AUDUBON COVE SUBDIVISION

APPLICATION NUMBER 7 DATE November 18, 2004

APPLICANT Audubon Cove Subdivision

REQUEST Subdivision

SUBDIVISION PLAT

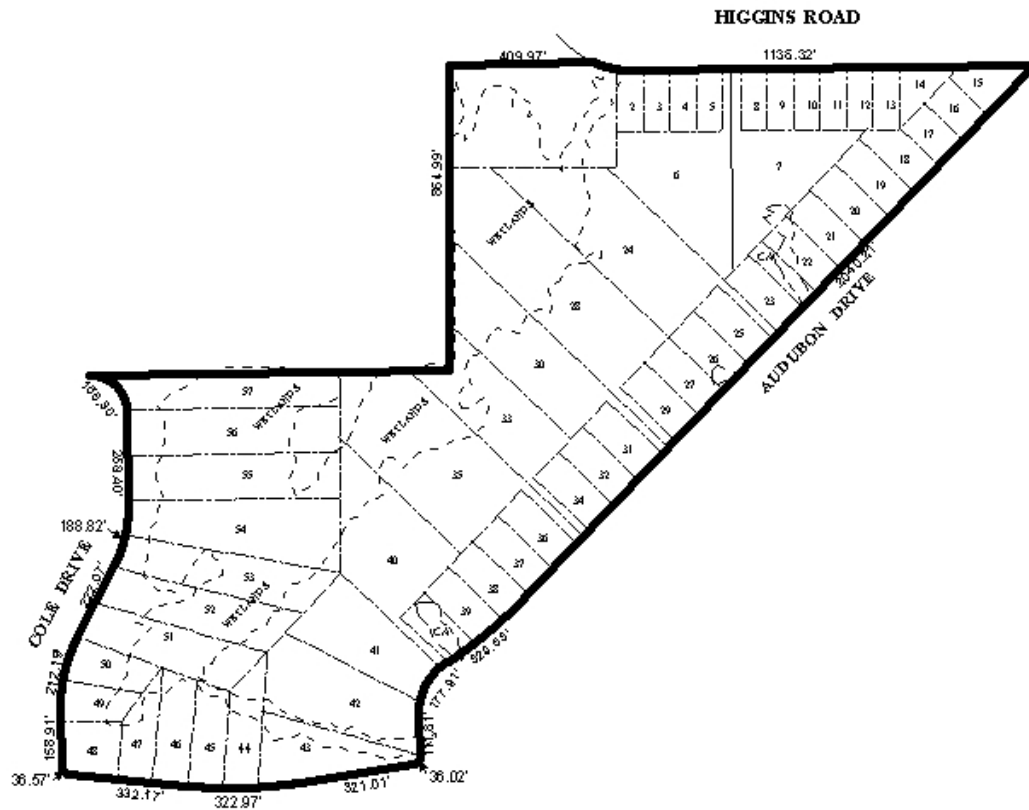
Engineering Comments: Engineering requests dedication of Flood Plain easement. Minimum finished floor elevation required on each lot. Stormwater detention must be achieved above the 100-year flood elevation which is not as shown on the preliminary plat. Must comply with all stormwater and flood control ordinances. Any work performed in the right of way will require a right of way permit.

There are wetlands located on the site, thus the area could be considered environmentally sensitive; therefore, the approval of all federal, state and local agencies would be required.

There are eight flag-shaped lots within the subdivision, thus a waiver of Section V.D.3., would be required. While flag-shaped lots are typically discouraged, due to the wetlands and the fact that the flag lots are clustered such that no more than two flag lots have adjoining access points, with a limitation on curb cuts, a waiver of Section V.D.3. would be appropriate.

With a waiver of Section V.D.3, the plat will meet the minimum requirements of the Subdivision Regulations and is recommended for Tentative Approval subject to the following conditions: 1) the approval of all applicable federal, state and local agencies; 2) the placement of a note on the final plat stating that Lots 6-7; 28-30, and 33-35 will share one curb cut; and 3) full compliance with the City Engineering Comments (must comply with all stormwater and flood control ordinances; any work performed in the right of way will require a right of way permit; developer must provide an approved outfall into a City of Mobile maintained system at any point of discharge where one does not exist; this development contains one or more points of discharge where an acceptable outfall does not exist, thus, the developer will be required to provide outfall approved by the City Engineer).
